UNITED STATES PATENT AND TRADEMARK OFFICE

APPLICATION NO.	FILING DATE	FIRST NAMED INVENTOR	ATTORNEY DOCKET NO.	CONFIRMATION NO.
10/622,150	07/16/2003	Matthew Louis Courcy	NSC-P05579	1923

Office Action Summary	Application No. 10/622,150	Applicant(s) COURCY, MATTHEW LOUIS	
	Examiner Howard L. Williams	Art Unit 2819

- 1) ☒ Responsive to communication(s) filed on 03 January 2006.
- 2a) ☒ This action is **FINAL**. 2b) ☐ This action is non-final.
- 3) ☐ Since this application is in condition for allowance except for formal matters, prosecution as to the merits is closed in accordance with the practice under *Ex parte Quayle*, 1935 C.D. 11, 453 O.G. 213.

Eitrheim et al. in figure 5 discloses a clock generation circuit that includes an

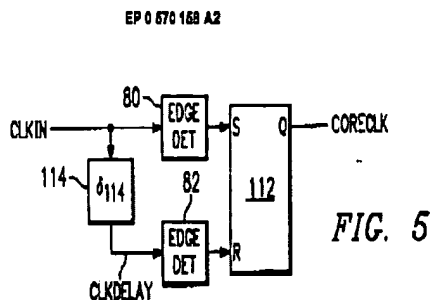
edge detector 80, conditioning circuit 114 and an R-S latch. Eitrheim also discloses that the clock output ("CORECLK" in the figure) is independent of the duty cycle of the input clock (abstract and col. 11, line 31).
